TO: HEARINGS OFFICER

FROM: LISA ANDERSON-OGILVIE, AICP, DEPUTY COMMUNITY DEVELOPMENT DIRECTOR AND PLANNING ADMINISTRATOR

**SUBJECT: CONDITIONAL USE / CLASS 3 SITE PLAN REVIEW / CLASS 2 ADJUSTMENT / CLASS 2 DRIVEWAY APPROACH PERMIT / CLASS 1 DESIGN REVIEW CASE NO. CU-SPR-ADJ-DAP-DR21-02
3200 BLOCK OF BOONE ROAD SE - 97317
AMANDA NO. 20-116280-ZO, 20-116282-RP, 20-116283-ZO, 20-116281-ZO & 20-116285-DR**

Summary: Development of a new fifteen building apartment complex with 210 dwelling units.

OVERALL SITE PLAN

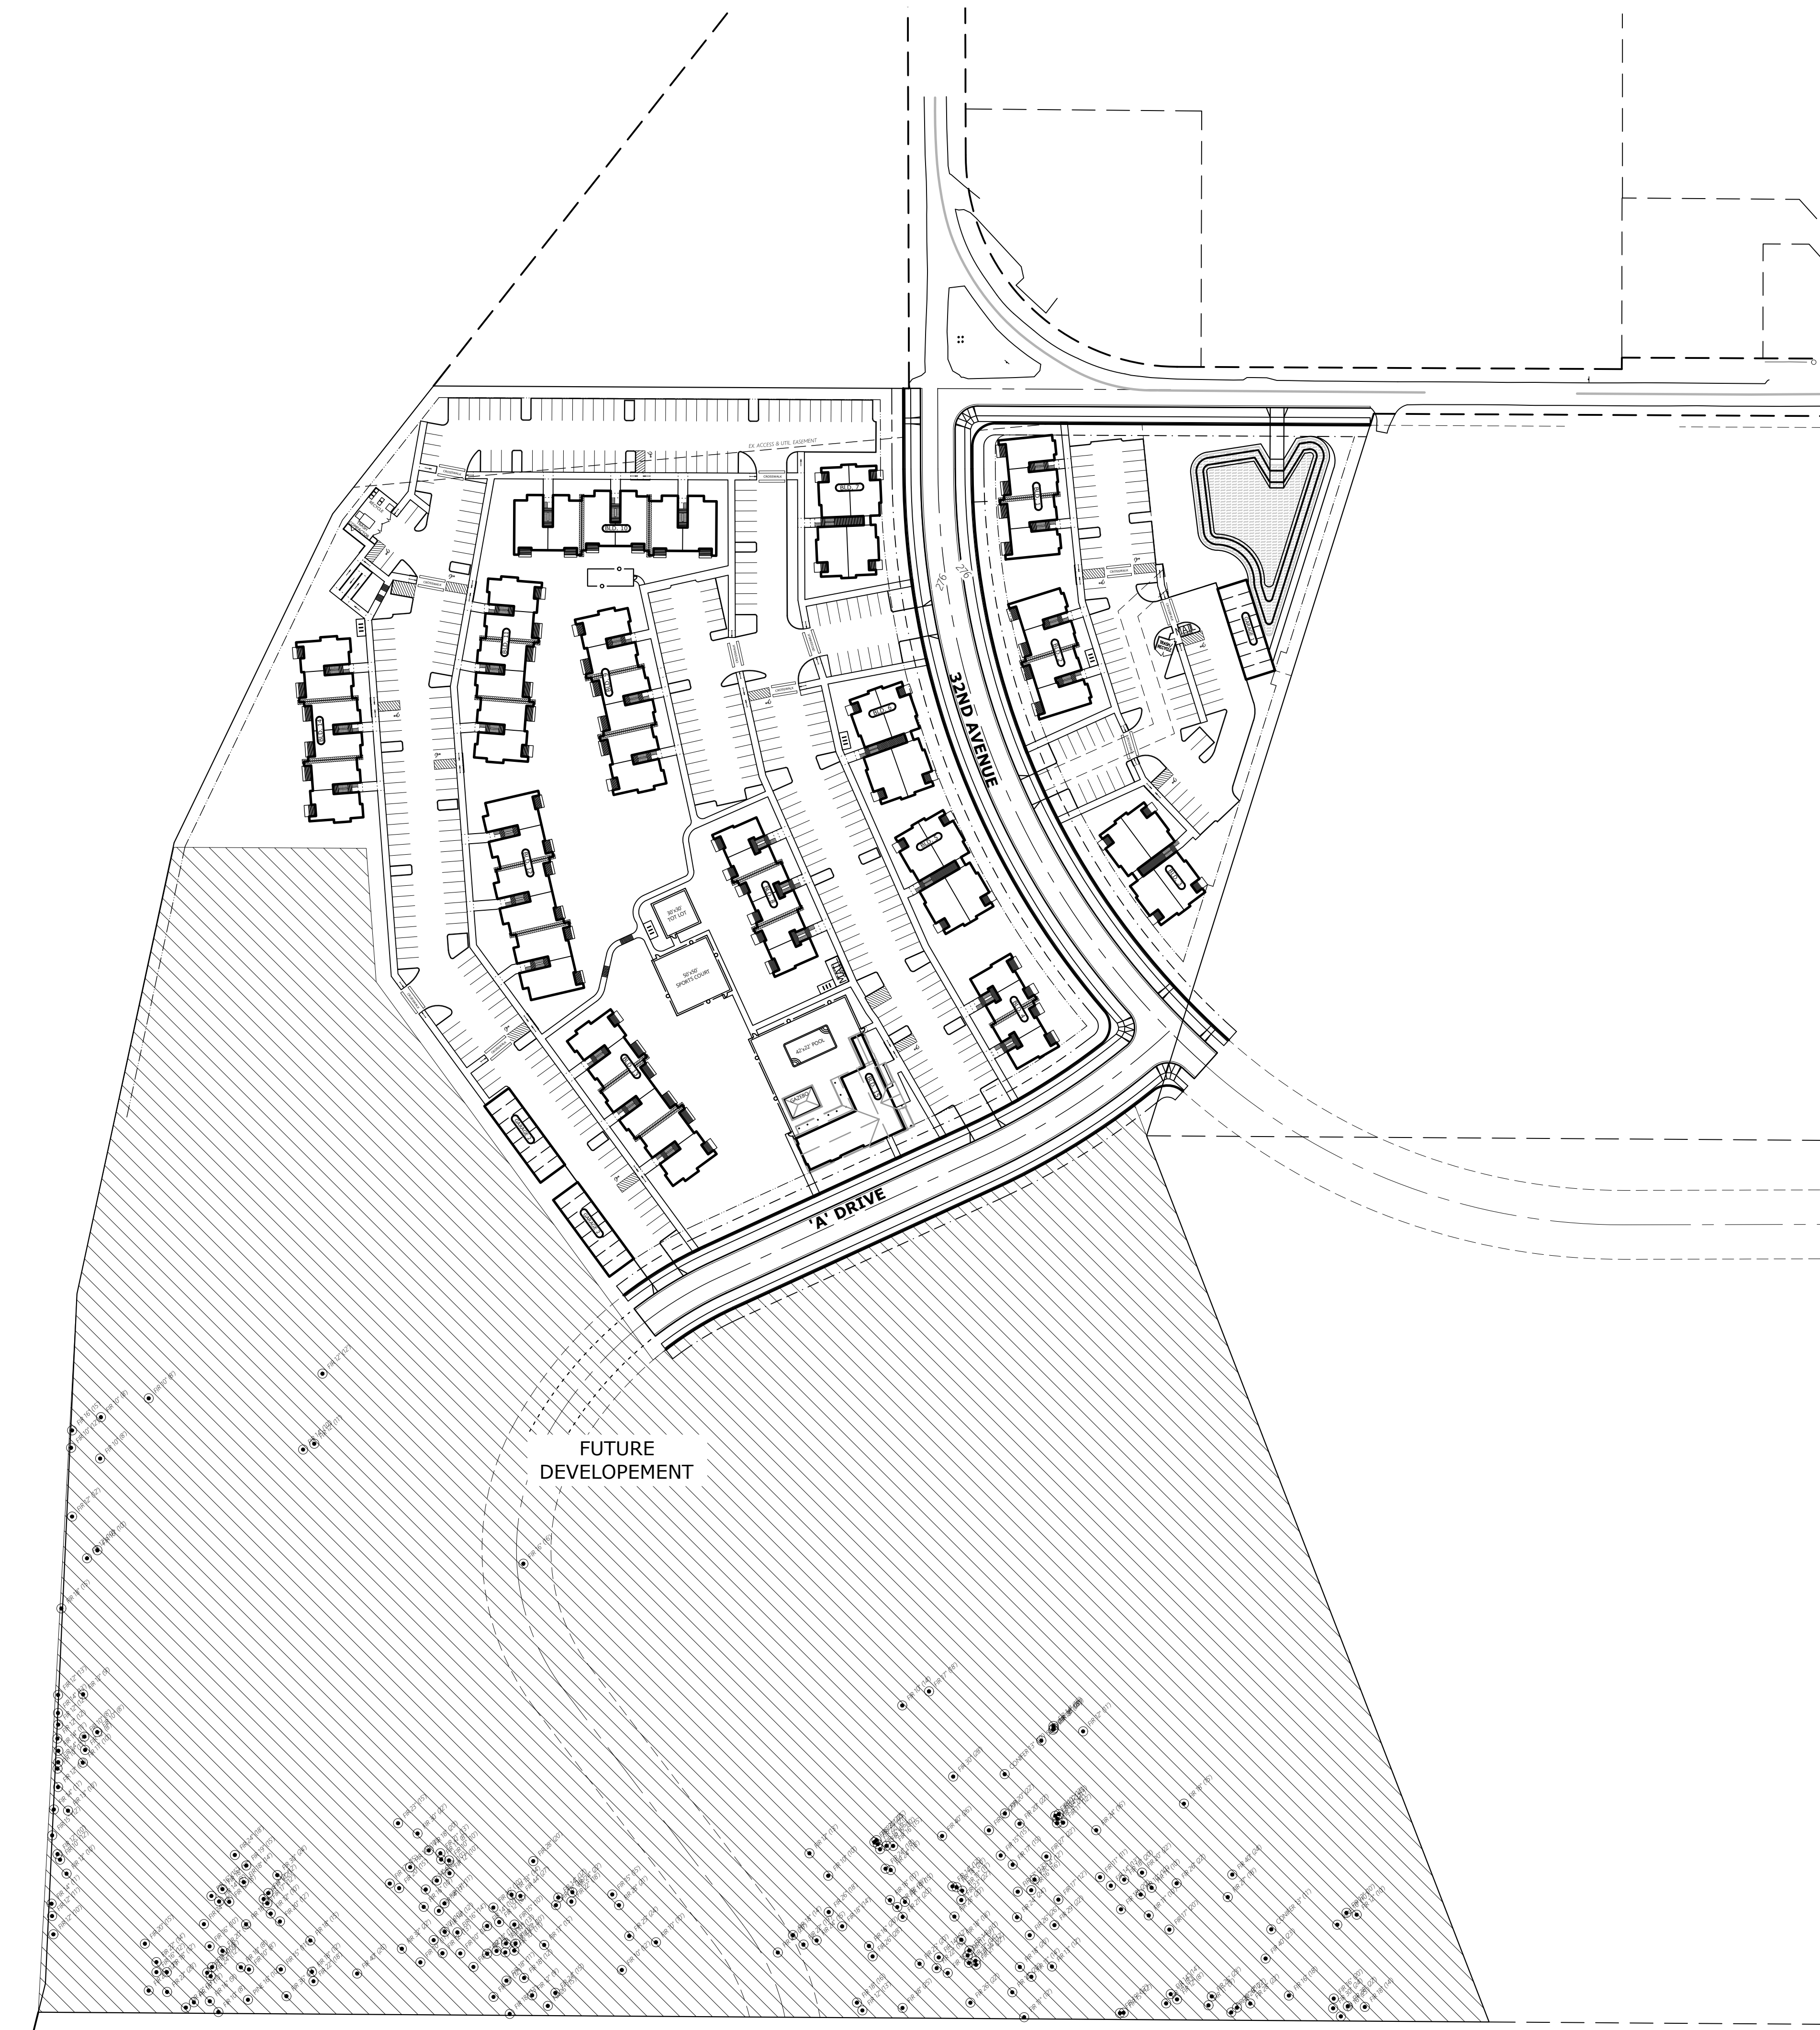
Finding: On the eastern portion of the site, proposed Building 1 is setback approximately 10 feet from Boone Road SE, and the proposed off-street parking area is setback approximately 13 feet, in compliance with this standard. On the western portion of the site, a proposed vehicle use area abuts the IG zoned property to the north, the site plan indicates that the vehicle use area will have a 10-foot setback, less than the minimum 15-foot standard. As a condition of approval of building permit issuance, the applicant shall revise the site plan to comply with the minimum setback requirement.

Finding: Proposed Building 3 is setback approximately 15 feet from the property to the east, in compliance with the setback requirement. The site plan indicates that the vehicle use area will have a 10-foot setback, less than the minimum 15-foot standard. As a condition of approval of building permit issuance, the applicant shall revise the site plan to comply with the minimum setback requirement.

Finding: As indicated in the findings above, the vehicle use area setbacks are not met to the north and to the east. The applicant shall revise the site plan to comply with minimum setback requirements. As conditioned, the proposed vehicle use area complies with the minimum perimeter setback standards

Finding: The site plan shows four individual bicycle parking pads, each with three staple racks, which provide two bicycle parking spaces each, for a total of twenty-four bicycle parking spaces. However, one of the bicycle parking pads with required bicycle parking spaces is provided near the proposed tot lot and sports court in a location more than 50 feet from a primary building entrance, and therefore not in compliance with SRC 806.060(a)(1). At the time of building permit, the applicant shall demonstrate that the bicycle parking pads comply with all applicable development standards of SRC Chapter 806.

Condition 6: Prior to building permit issuance the applicant shall revise the site plan to comply with the minimum vehicle use area setback requirement to the north and east.
